HISTORIC AND DESIGN REVIEW COMMISSION

October 07, 2020

HDRC CASE NO: 2020-381
ADDRESS: 506 E COURTLAND PLACE
LEGAL DESCRIPTION: NCB 2964 BLK 3 LOT 19
ZONING: R-6, H
CITY COUNCIL DIST.: 1
DISTRICT: Tobin Hill Historic District
APPLICANT: Richard Stewart/STEWART RICHARD S & LESLIE T
OWNER: Richard Stewart/STEWART RICHARD S & LESLIE T
TYPE OF WORK: Front yard fence installation
APPLICATION RECEIVED: August 21, 2020
60-DAY REVIEW: Not applicable due to City Council Emergency Orders
CASE MANAGER: Rachel Rettaliata

The applicant is requesting a Certificate of Appropriateness for approval to install a 4-foot-high wrought iron front yard fence.

PRODUCT: PICKET STYLE PANEL

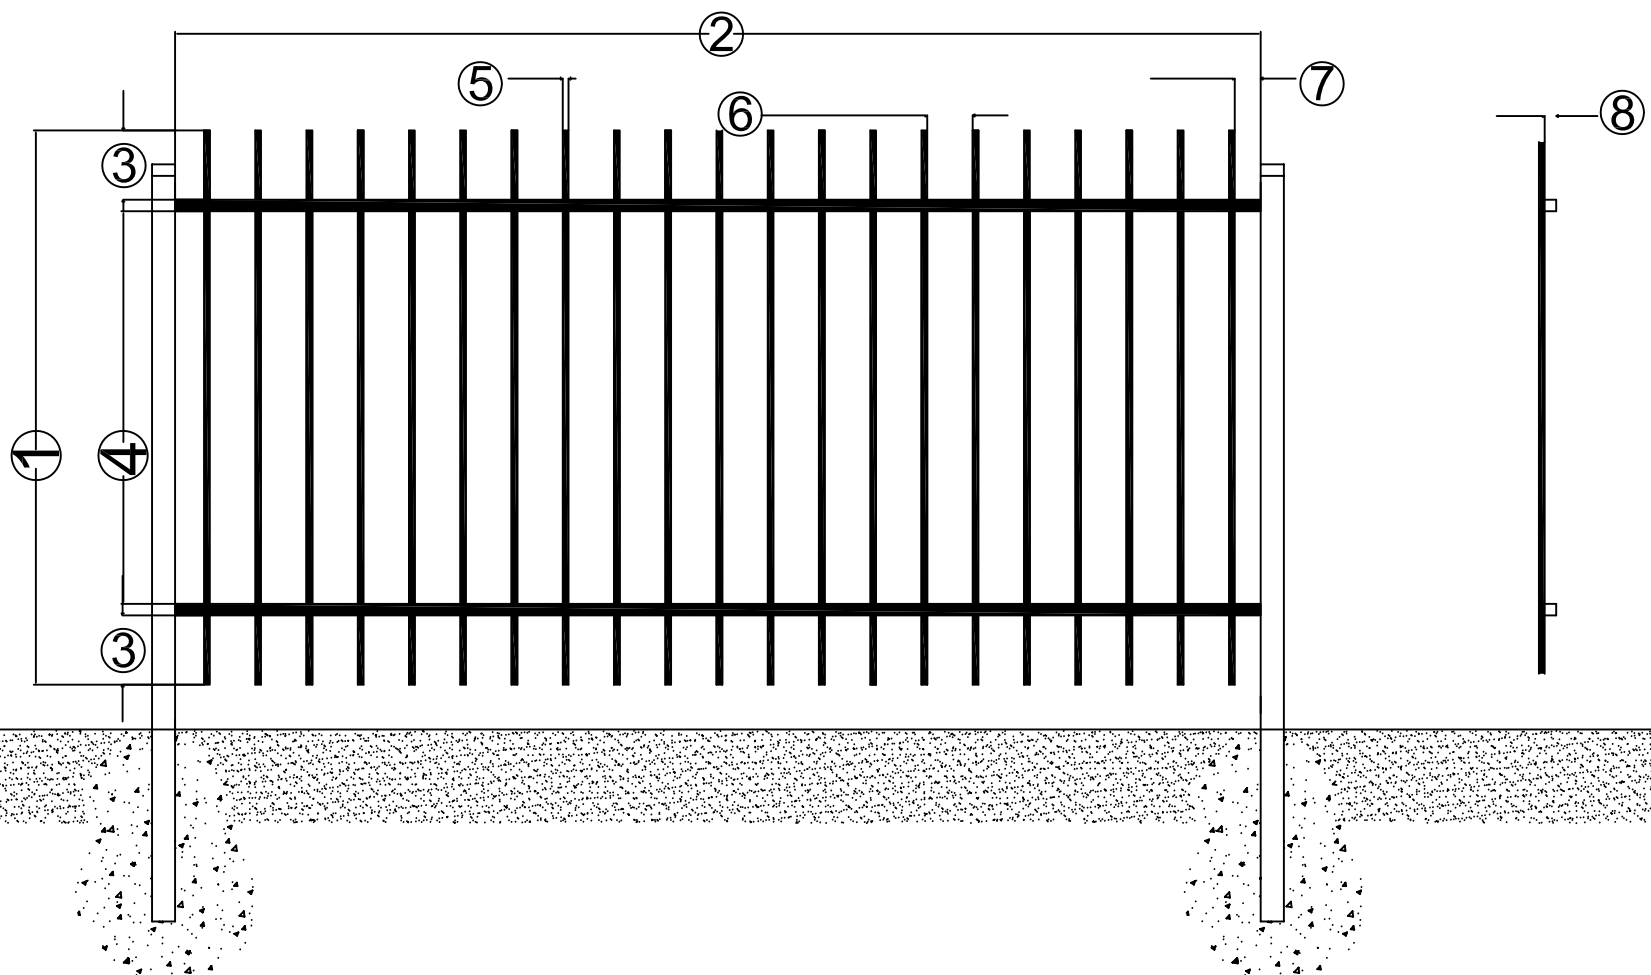
- c. FENCE DESIGN AND HEIGHT – The applicant has proposed to install a 4-foot-tall wrought iron fence in the front yard. The fence will feature a driveway gate that is setback from the front yard fence line but is not set behind the front façade wall plane due to existing site conditions. The proposed fence will also feature a pedestrian gate at the top of the front walkway steps. According to the Historic Design Guidelines, new front yard fences should appear similar to those used historically within the district in terms of their scale, transparency, and character. Staff finds that traditional wrought iron fencing is generally appropriate for the Tobin Hill Historic District.

- i. That the final construction height of an approved fence may not exceed the maximum height as approved by the HDRC at any portion of the fence. Additionally, all fences must be permitted and meet the development standards outlined in UDC Section 35-514.
